# XRAY XT8

## INSTRUCTION MANUAL

## #351308 XT8 BODY POSTS - V2

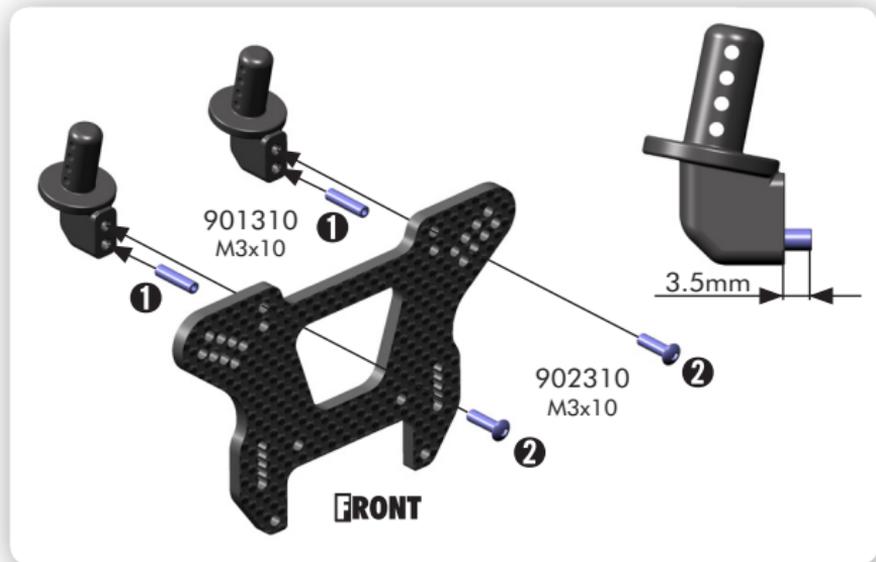
These new front body posts have holes for additional set screws, which will prevent the body posts from twisting after a crash.
